May 2, 2024
AVO 37449.004

Re: Lane Ranch Phase 1 Preliminary Plat -Review #3

Halff Associates, Inc. was requested by the City of Sanger to review the Preliminary Plat for Lane Ranch Phase 1. The submittal was prepared by Middleton and Associates, LLC and was dated February 2, 2024.

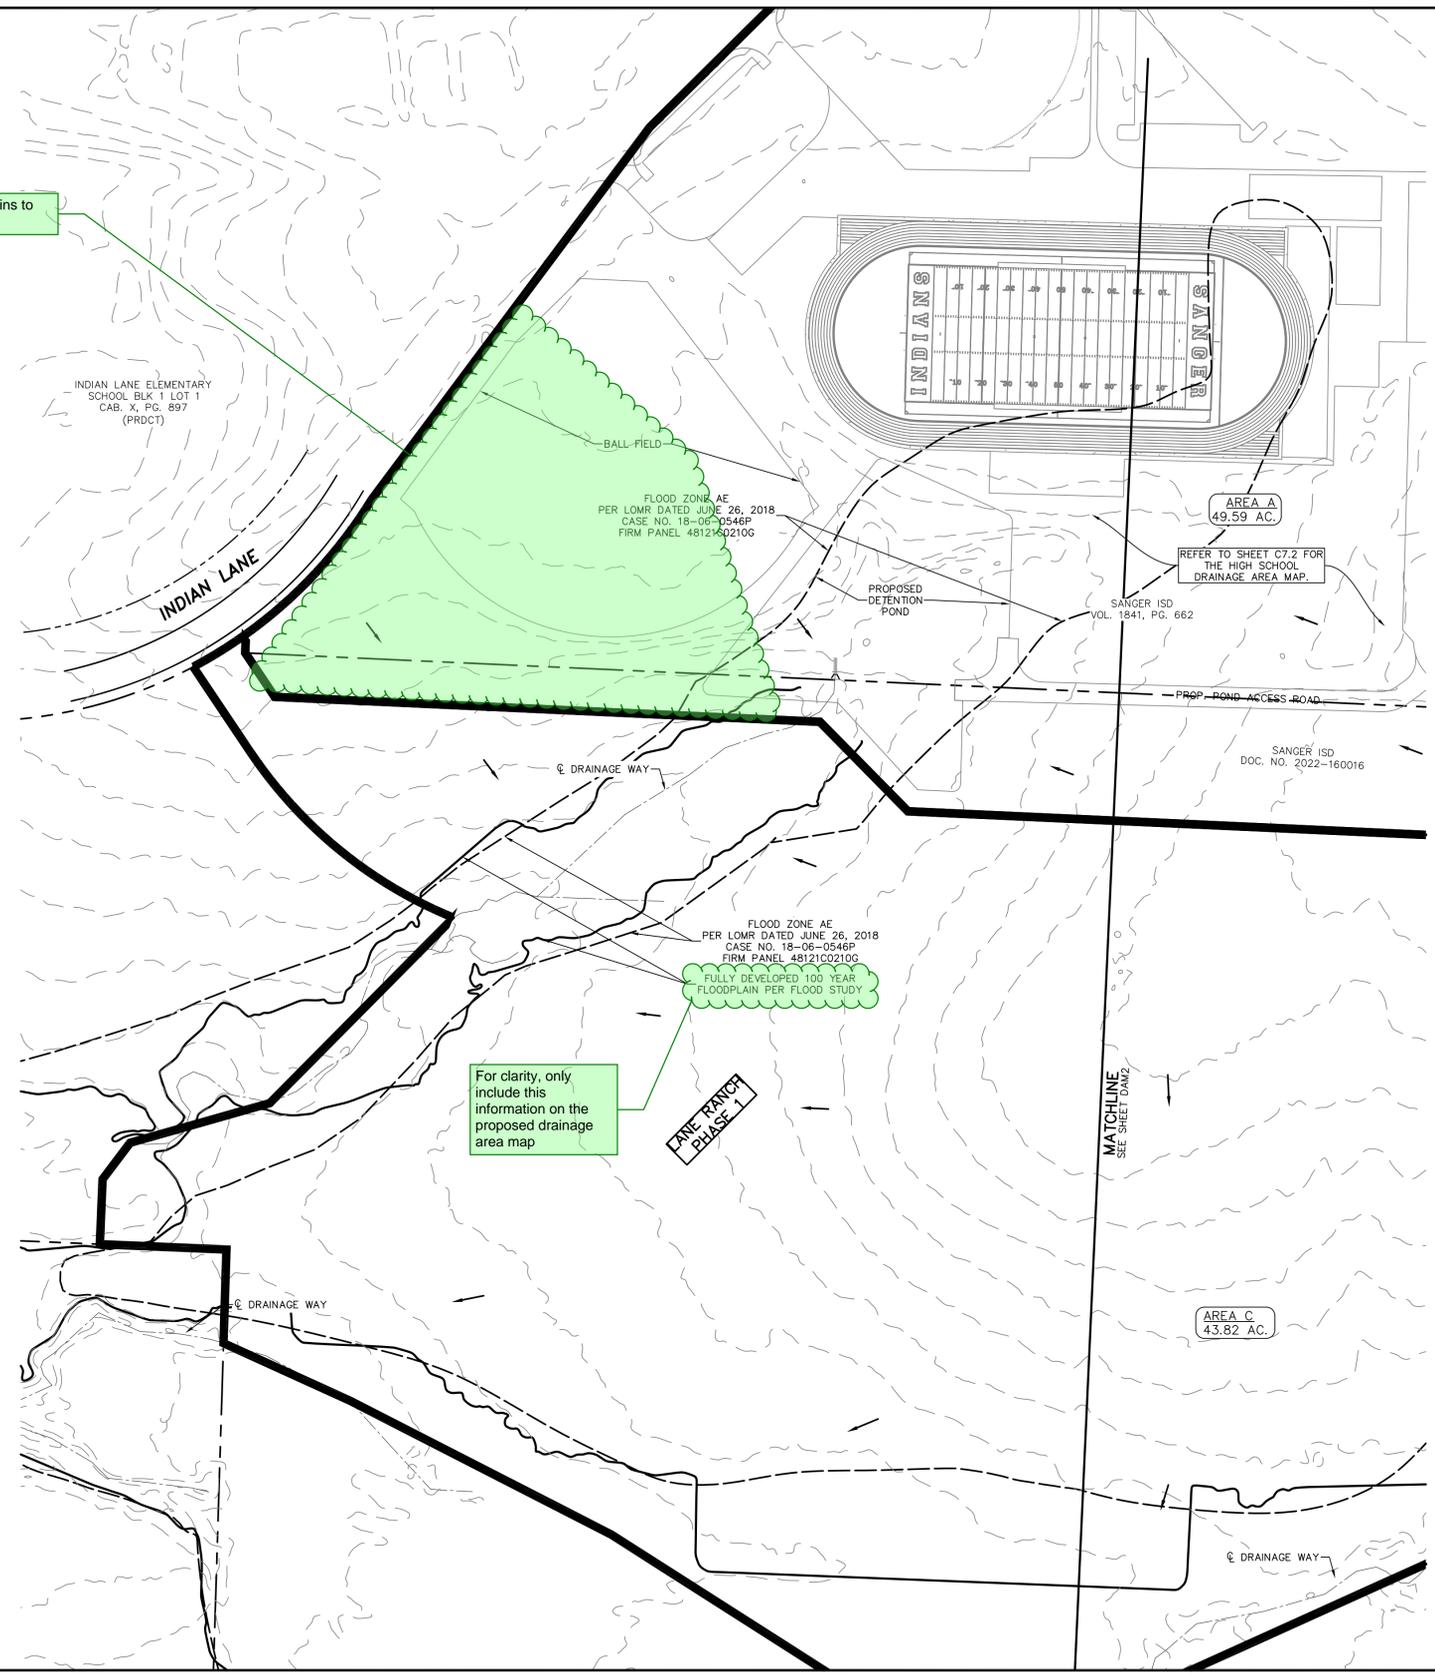
This area drains to the site

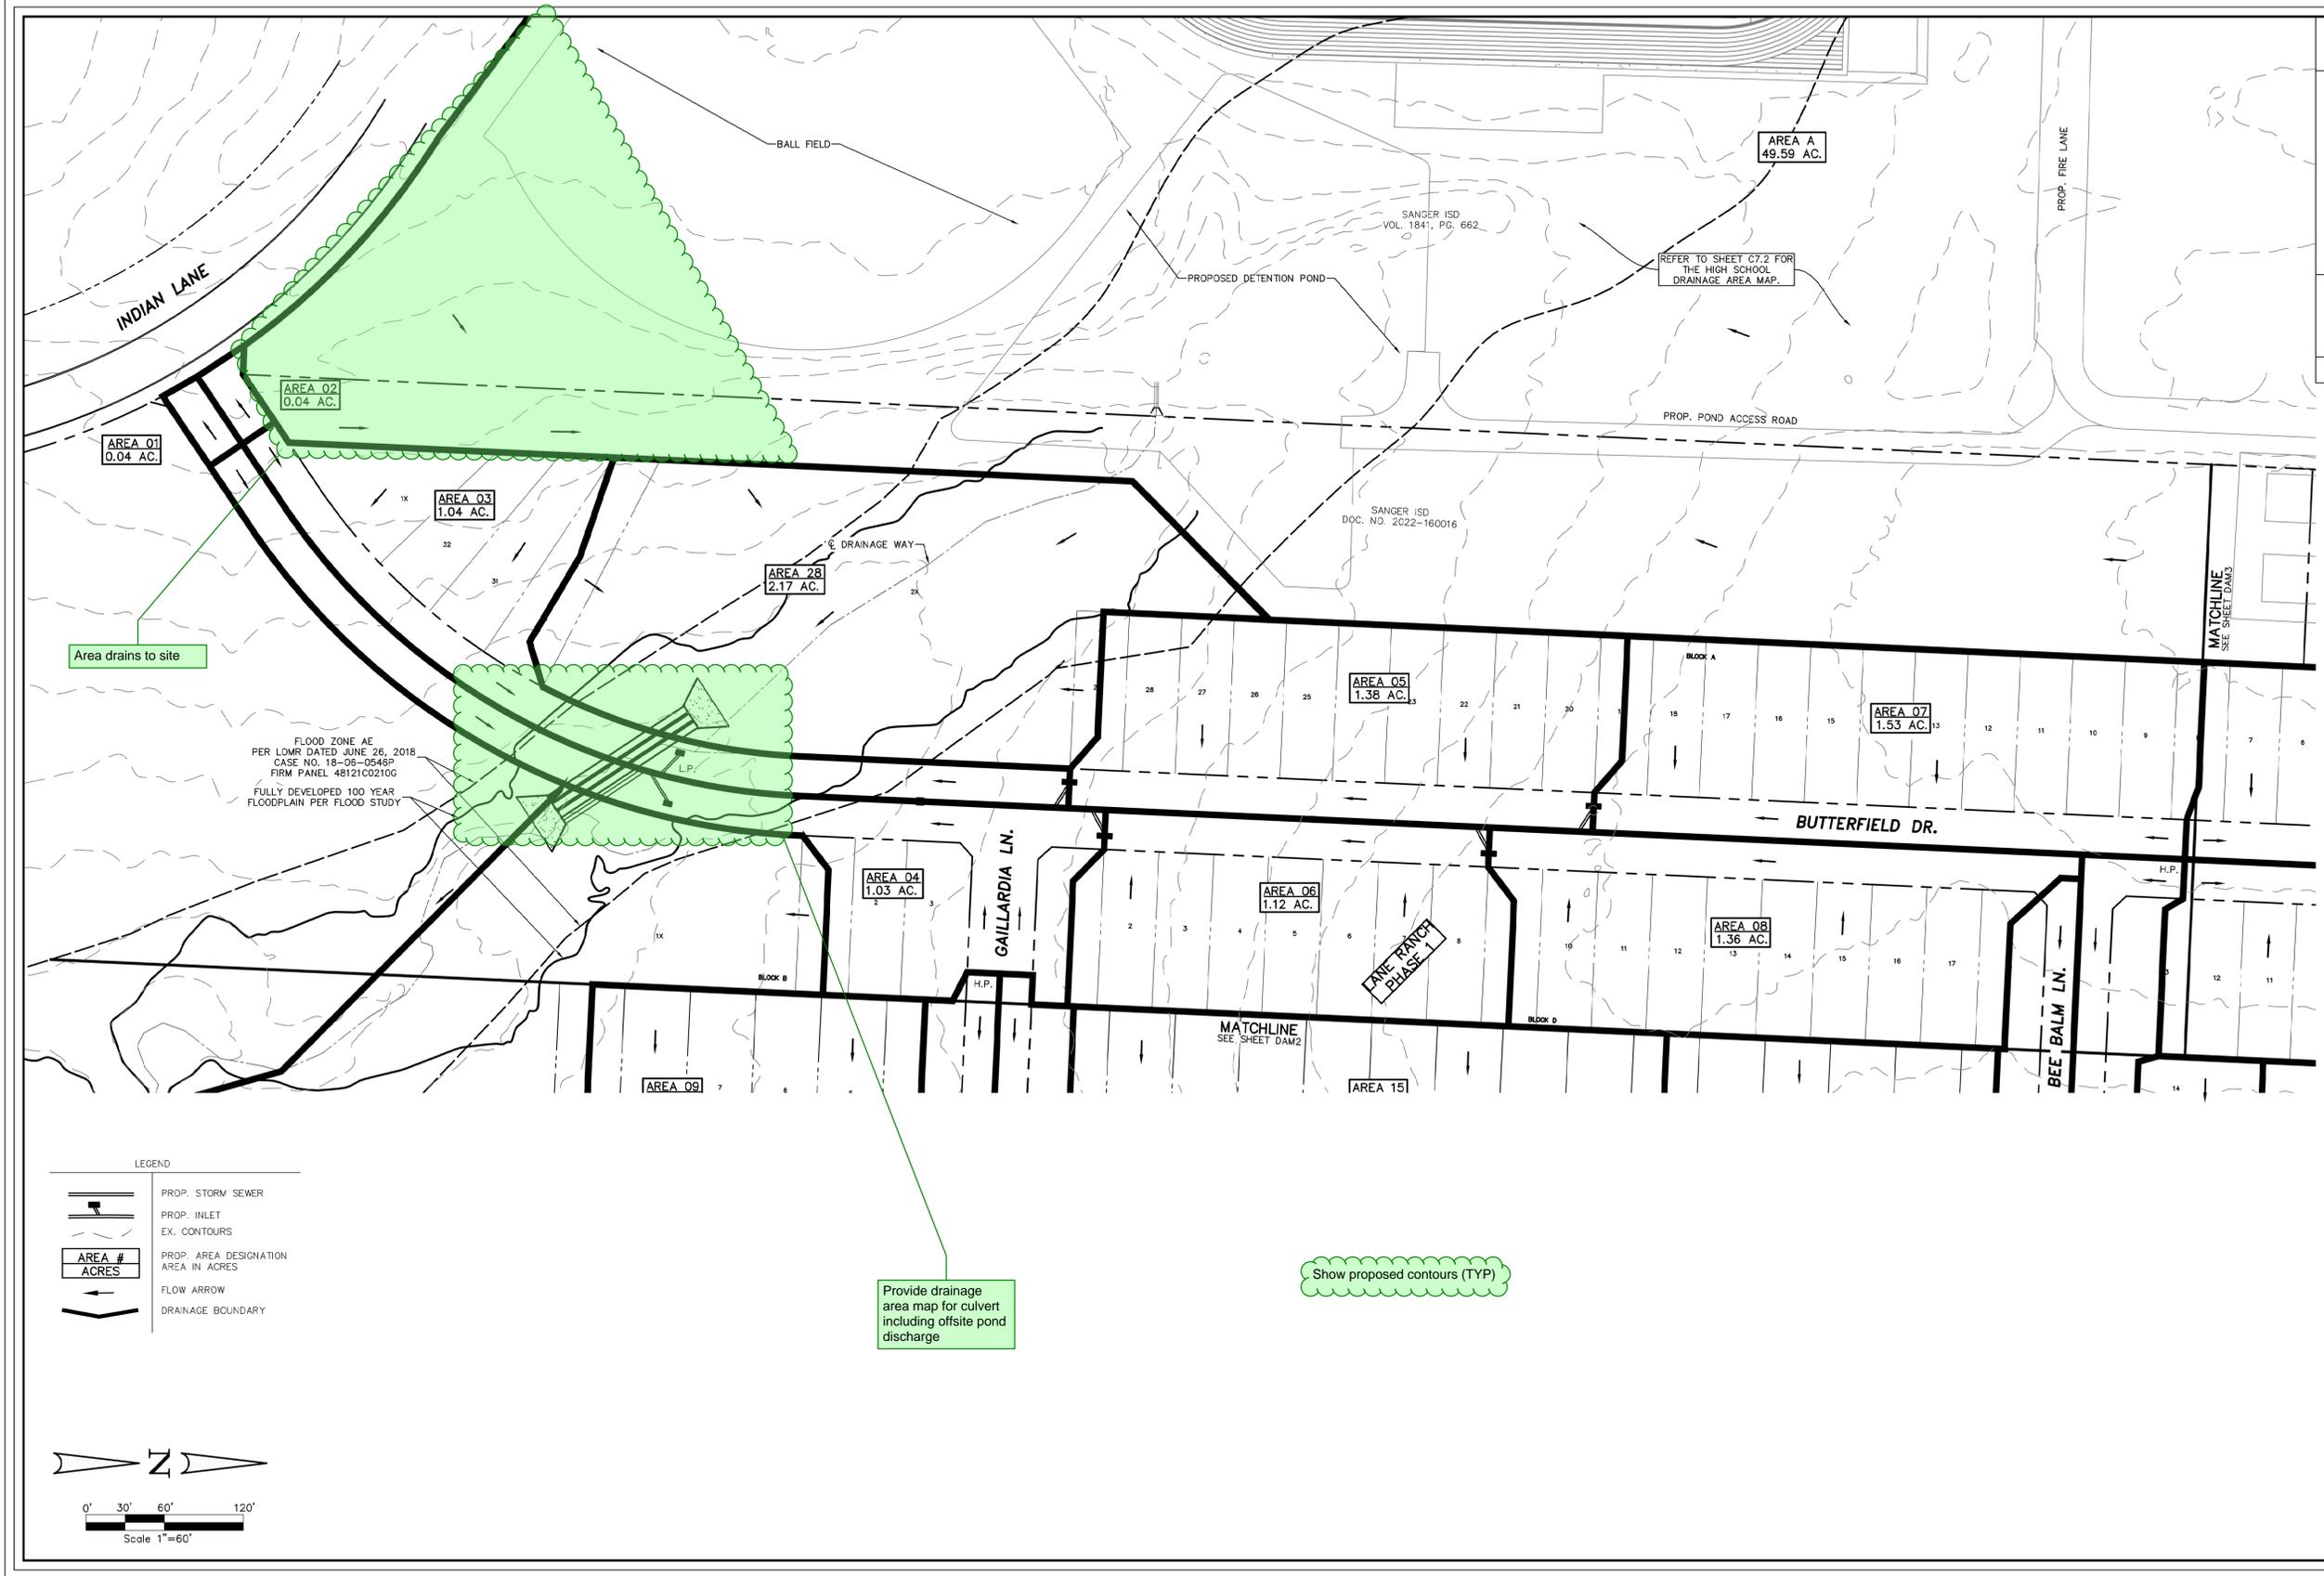
Provide drainage
area map for culvert
including offsite pond
discharge

Show proposed contours (TYP)

SANITARY SEWER PLAN & PROFILE
SS LINE D
STA. 0+00 - 4+00
LANE RANCH, PHASE 1

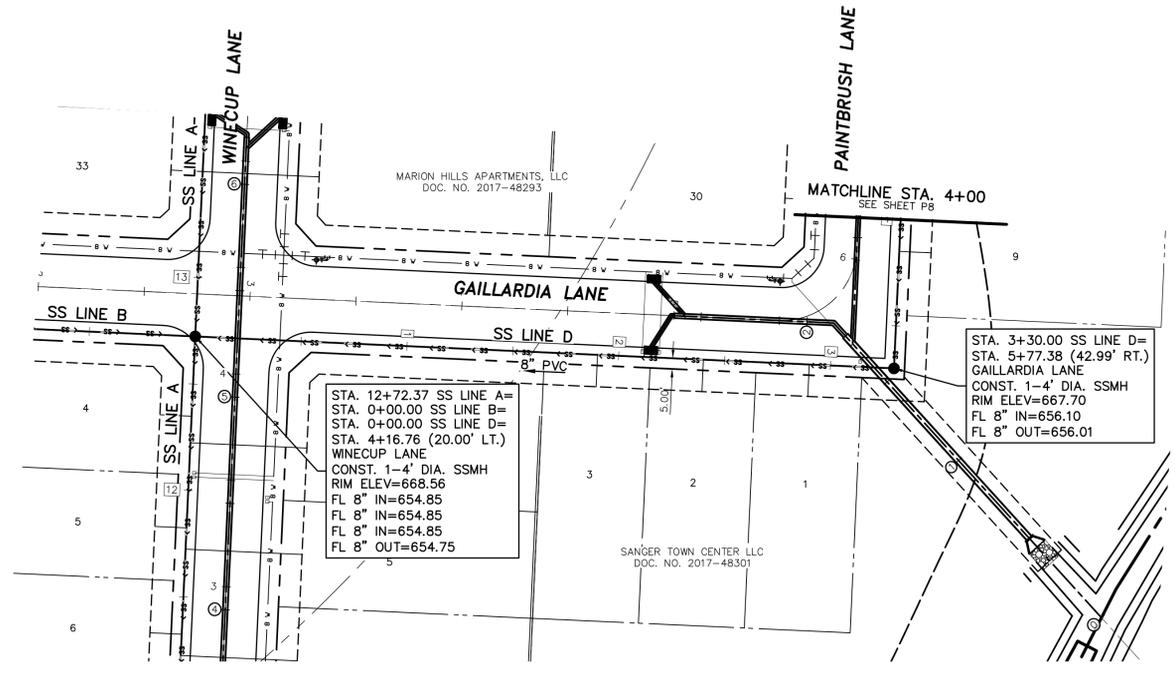
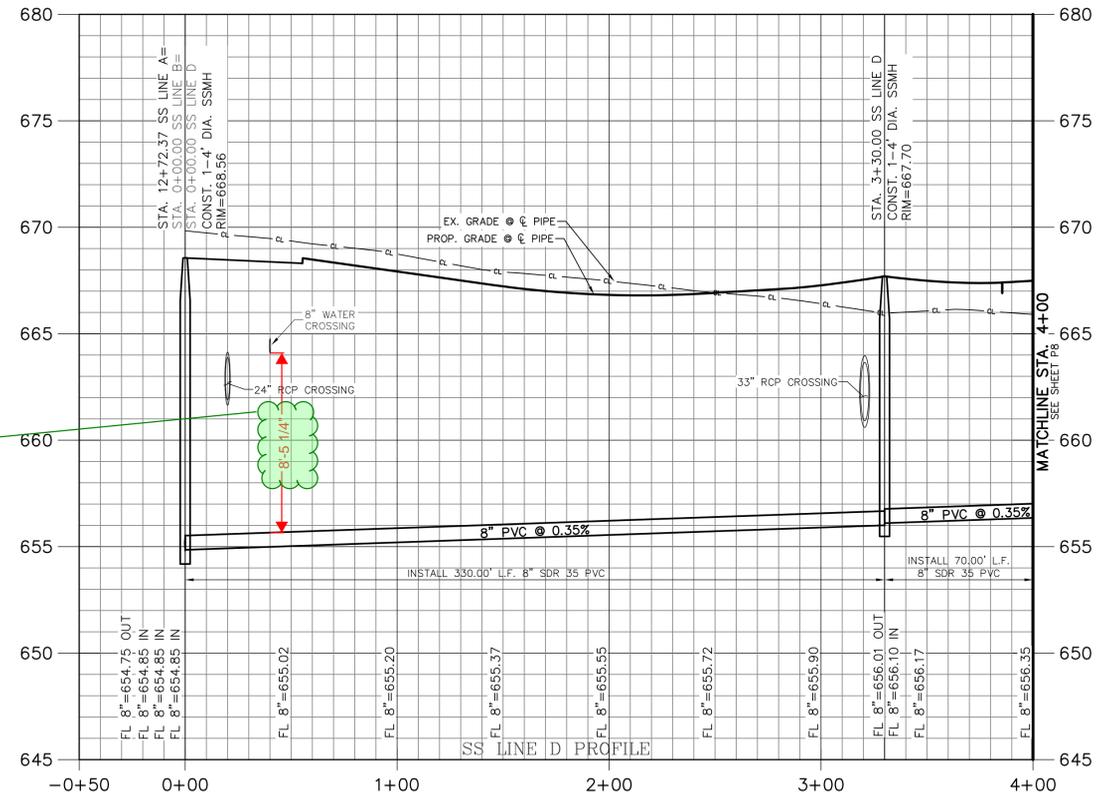
Does now meet clearance standard for TCEQ. Per TCEQ use pressure pipe or encase sewer at crossing
